COMMUNITY DEVELOPMENT DEPARTMENT

LOCATION: 870 S. Locust Grove Rd.

Annexation of 1.03 acres of land with the R-8 zoning district, and short plat consisting of 4 residential building lots.

A. Annexation and Zoning Legal Description and Exhibit

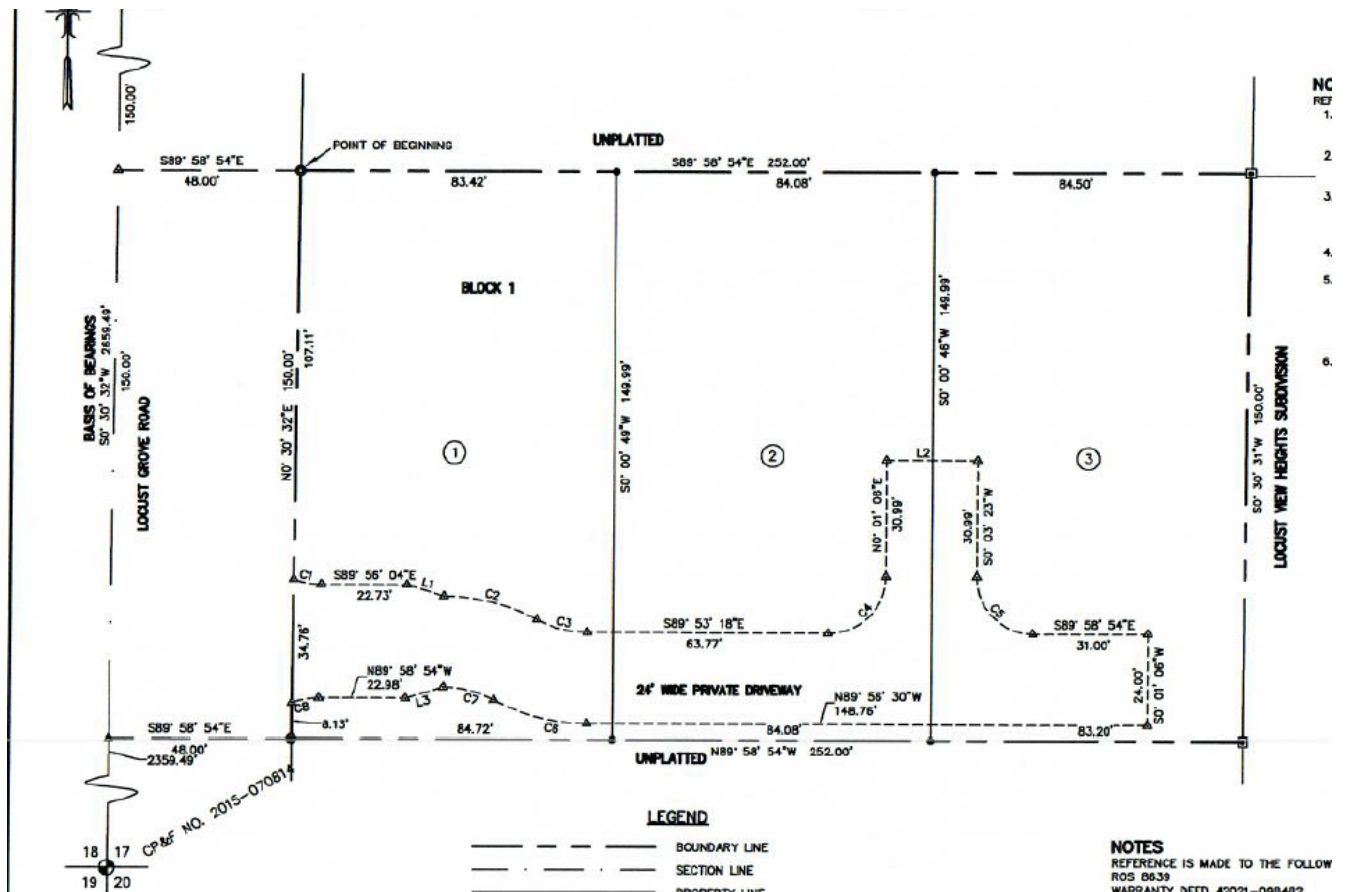
The submitted legal description and boundary exhibit to appear to encompass the area of annexation. However, the exhibit also includes a previous lot configuration of three lots. **Prior to recordation of the annexation ordinance, the applicant shall submit a revised boundary exhibit which correctly matches the legal description.**

- b. The 20-foot common driveway shown in the short plat shall be extended to the eastern property line in a 30 ft wide easement common lot and receive Fire Marshall approval to exceed 150 feet in accord with UDC 11-6C-3D. When the property to the east annexes into the City and develops, access to the subject property shall occur from S. Torino Ave. and the existing S. Locust Grove Road access shall be closed or used for emergency access purposes only.

3. Prior to recordation of the annexation ordinance, the applicant shall submit a revised annexation boundary exhibit.
 4. The applicant shall construct all proposed fencing and/or any fencing required by the UDC, consistent with the standards as set forth in UDC 11-3A-7 and 11-3A-6B, as applicable.
